Second Five-Year Review

Bunker Hill Mining and Metallurgical Complex Superfund Site
Operable Units 1, 2, and 3
Idaho and Washington

Responsiveness Summary

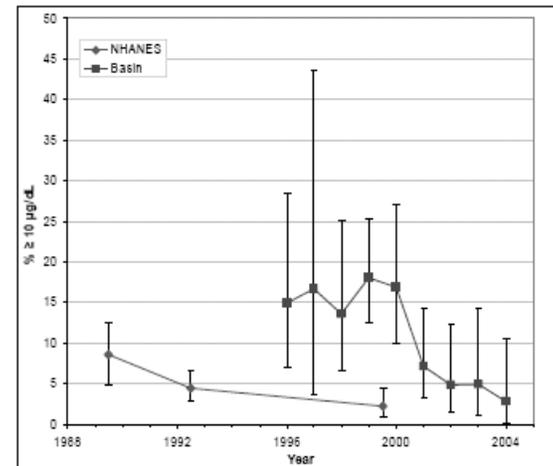
Observed blood lead declines were evaluated by the National Academies' National Research Council pre-publication report entitled *Superfund and Mining Megsites - Lessons from the Coeur d'Alene River Basin* (National Research Council, 2005). The report focuses on Operable Unit 3 and states on page 139-140:

Between 2000 and 2001, an apparent sharp decline in geometric mean blood lead is observed. This apparent decline may be an artifact of nonrepresentative sampling. If it is real, it appears to be much more rapid than the background rate of decline occurring in the national population. One possibility is that the decline is real and attributable to remedial activities in the Coeur d'Alene River Basin. Between 1997 (the inception of remedial activities) and 2000, 66 residences, 6 schools or daycare centers, and 5 common-use or recreational properties were remediated (TerraGraphics, URS Greiner Inc. & CH2M HILL, 2001), Table 2.3-1). Remediation of that number of properties could have contributed substantially to declining blood lead, since cleanups were intended to first address sites posing the greatest apparent threats, and blood sampling was not random. In any case, this apparent improvement in the Coeur d'Alene River Basin results was observed only after substantial remedial activity.
